Service Bulletin

SAFETY RECALL

2007-2008 VTX1300C/R/S/T Fuel Valve Diaphragm Replacement

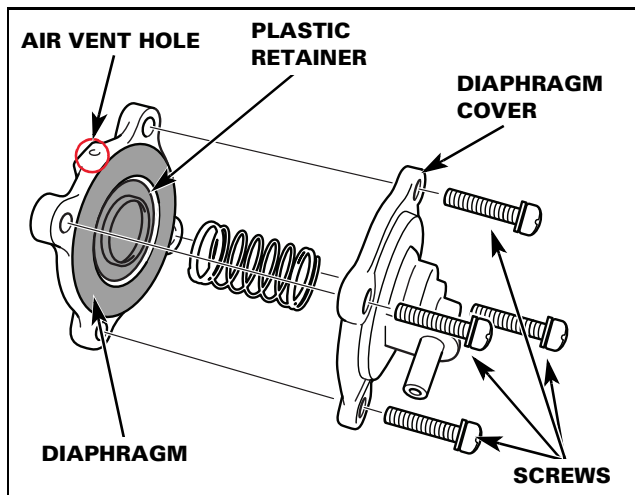
1. Remove the fuel tank using the procedure in the Service Manual. However, do not remove the fuel valve from the fuel tank.
2. Drain the fuel into an approved container.
3. Remove the four screws and diaphragm cover.

NOTE: The diaphragm cover is under spring pressure. Do not lose the spring or screws. The countermeasure part has a paint mark near the air vent hole.

4. Replace the diaphragm, spring, cover, and screws with new parts included in the kit. Install the new diaphragm with the plastic retainer facing the diaphragm cover.

NOTE: Make sure the air vent hole is facing downward towards the ground.
